# Microsystem Design

## Errata

The following errors occur in the First Printing

This list compiled on March 9, 2002

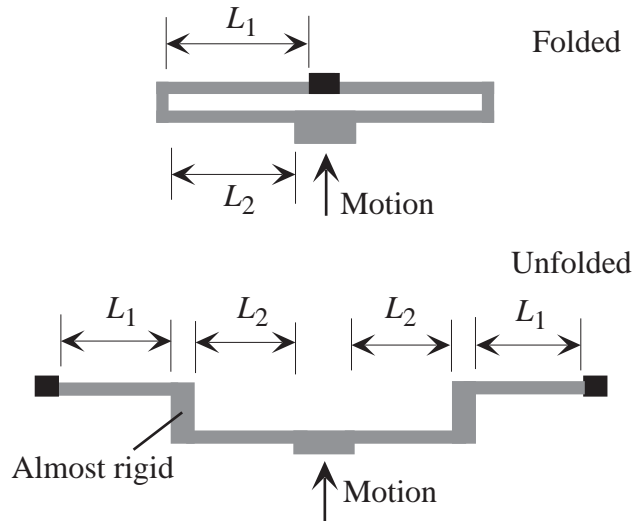
**Page 518** There is a serious error in Fig. 19.22 and the associated analysis. The unfolding of the beam as shown neglects the fact that the short folds behave as almost rigid structures. Therefore, a more accurate picture is as shown below:

**Page 519** Because of the error in Fig. 19.22, the corresponding analysis leading up to Eq. 19.20 is incorrect. The unfolded spring is, if we assume that the short folds are perfectly rigid, equivalent to two doubly supported fixed-fixed beams, one of length  $2L_1$ , the other of length  $2L_2$ . Because the two springs share a common force (effort), their equivalent circuit is in parallel. Hence, the two capacitances corresponding to the springs add. The net result is that the spring stiffness calculated in Eq. 19.20 should be

$$k = \frac{F}{c} = \left( \frac{\pi^4}{6} \right) \left[ \frac{EWH^3}{(2L_1)^3 + (2L_2)^3} \right]$$

The text that follows refers to  $2L$ , whereas it should identify both  $2L_1$  and  $2L_2$  as the lengths of the unfolded springs. Further, the lengths of  $L_1$  and  $L_2$  are estimated incorrectly from the photograph in Fig. 19.18. The stated values of  $75 \mu\text{m}$  are, more accurately, in the range  $110 - 120 \mu\text{m}$ . Interestingly enough, if  $120 \mu\text{m}$  is used, the resulting stiffness is within a few percent of the originally printed value of  $2.8 \text{ N/m}$  which resulted from the incorrect figure in combination with the incorrect lengths. Therefore, the remaining conclusions are unaffected, even though this intermediate calculation, as originally printed, was incorrect.
